Interactive comment on “Bipolar long-term high temporal resolution broadband measurement system for incoming and outgoing solar UV radiation, and snow UV albedo, at Sodankylä (67°N) and Marambio (64°S)” by O. Meinander et al.

Authors' response to the review of the Anonymous Referee #2

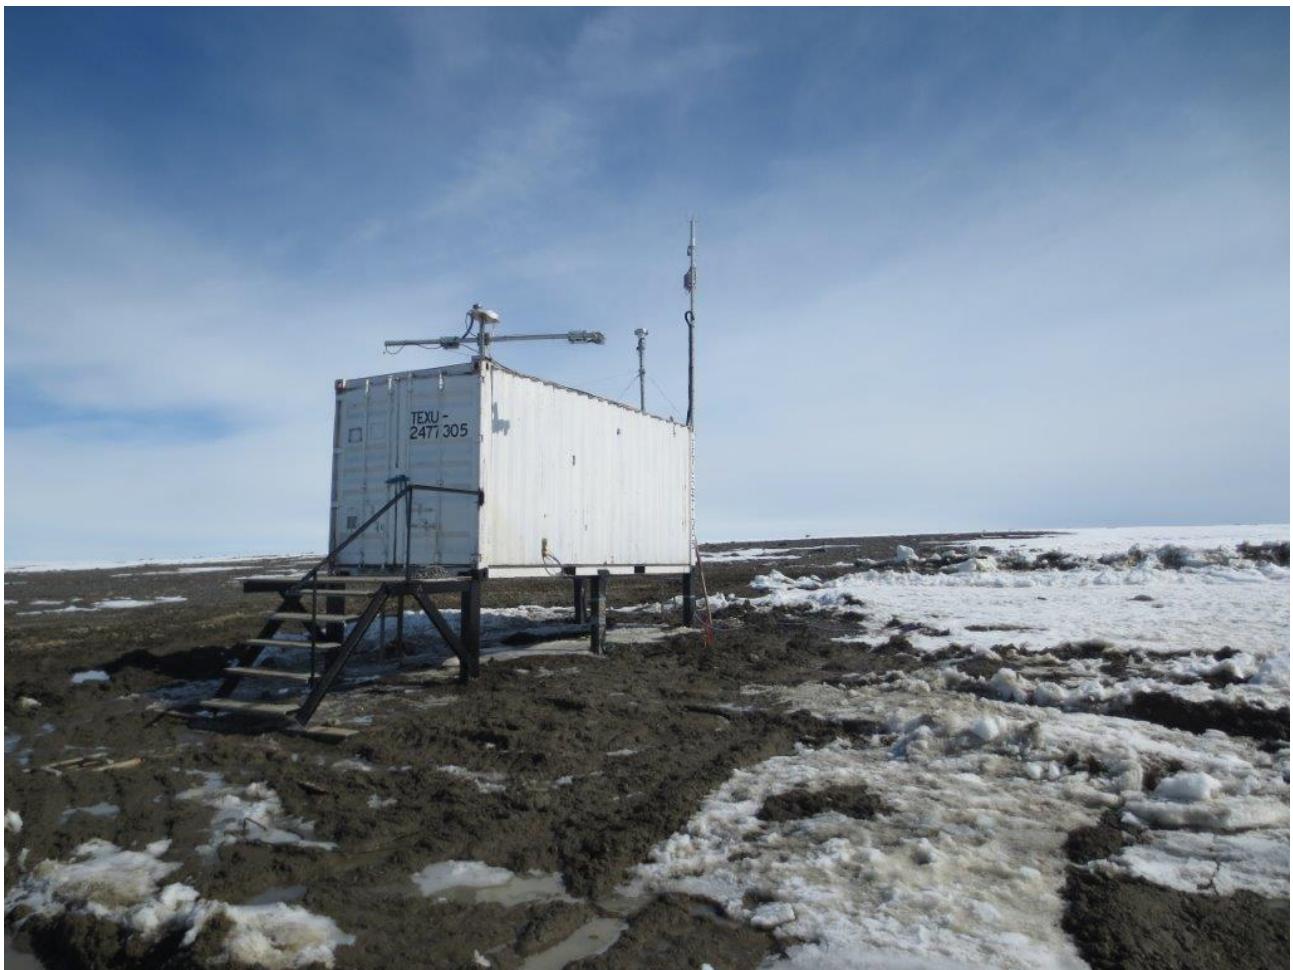
1. The Marambio measurements appear to be made in a large container, although this isn't entirely clear. This setup needs a fuller explanation and an assessment of the effect of the container on the measurements through shadowing and impact on wind drift needs to be evaluated.

We agree that a clarification on the measurement place is needed. A new photograph (below) is suggested to be inserted in the revised manuscript. The photo shows the horizontal pole where the downward sensor will be (is) attached (the pole will be/has been put as far from the container as possible; in this figure the pole is attached from the middle).

We agree with the referee that the effects of shadowing and wind drift are important to be included in the considerations of the revised manuscript. We agree that more effort needs to put in describing both of these effects, as will be explained here below. However, we also state that both of these effects could be a subject of an entire paper, and such papers have been published, too.

In Marambio, the container was placed in the middle of an open large field with >100 m by >100 m and sensor was placed toward the Sun (North), and the distance to one direction (South), i.e., the container, was appr. 2-3 m. The Marambio measurement height was appr. the same (2 - 2.5 m) as for Meinander and Räisänen (2010) case. Therefore, considering these distances, the error due to the container in the albedo measurements are not to be expected to be bigger than the error caused in the case of Meinander and Räisänen (2010).

As an outcome, we suggest to include in the revised manuscript a first estimation to the shadowing effect of the container, in case of flat snow surface, based on the case by Meinander and Räisänen (2010). We also suggest including in the revised manuscript a more detailed description of the photographs and their availability for the albedo data user. For the incoming solar irradiance data, the shadowing and wind drift effects can only affect via multiple reflection from the environment reaching the upward looking sensor. Changes in these effects from the irradiance point of view we state to be insignificant for the usage of the irradiance data.
